Access Compliance Report

Public Rights-of-Way

(Curb Ramps)

Intersection ID: 44757	Main Street: BONNER_BRIDGE_CT	Cross Street: KINGS_PARADE_BV	Location: NW
ADA ID: D427A125254A	Ramp Type: Perp	Initial Pass/Fail: Fail	Overall Compliance: No
		Severity Score: 10

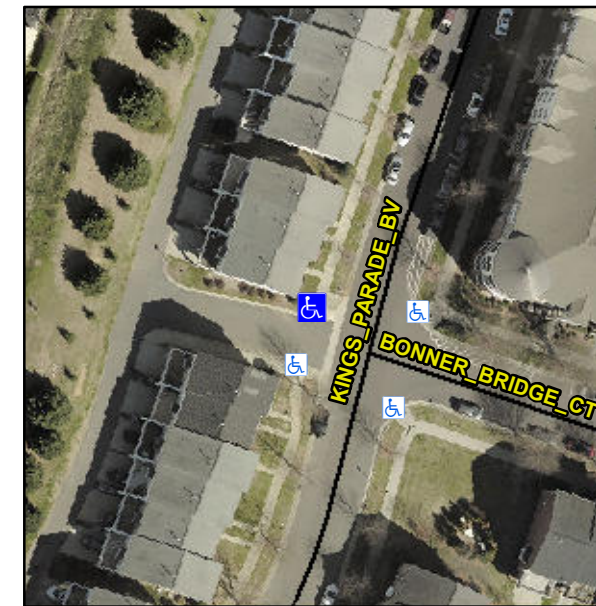
Not Found, R304.5.1, R304.5.3

Compliance	Description	Data	Compliance	Description	Data
N/A	Ramp Length (in)	85.0	Yes	Ramp Slope (%)	5.2
No	Ramp Width (in)	42.0	No	Ramp XSlope (%)	2.8
N/A	Flare Type LT	N/A	N/A	Flare Type RT	N/A
N/A	Flare Slope LT (%)	N/A	N/A	Flare Slope RT (%)	N/A
N/A	Flare Traversable LT?	N/A	N/A	Flare Traversable RT?	N/A
N/A	Landing Length (in)	N/A	N/A	DWS Provided?	N/A
N/A	Landing Width (in)	N/A	N/A	DWS Contrast?	N/A
N/A	Landing Slope (%)	N/A	N/A	DWS Length (in)	N/A
N/A	Landing X Slope (%)	N/A	N/A	DWS Full Width?	N/A
N/A	Landing Curb? (Y/N)	N/A	N/A	DWS Offset (in)	N/A
N/A	Shared Landing?	N/A			
N/A	Gutter Ponding?	N/A	N/A	Gutter Slope (%)	N/A
N/A	Gutter Lip Ht (in)	N/A	N/A	Gutter X Slope (%)	N/A
N/A	Painted X Walk1?	No	N/A	Painted X Walk2?	N/A
	X Walk 1 Direction	To S		X Walk 2 Direction	N/A
N/A	X Walk 1 Width (in)	N/A	N/A	X Walk 2 Width (in)	N/A
	X Walk 1 Slope (%)	2.1		X Walk 2 Slope (%)	N/A
	X Walk 1 X Slope (%)	5.0		X Walk 2 X Slope (%)	N/A

Remove & Replace Entire Ramp.
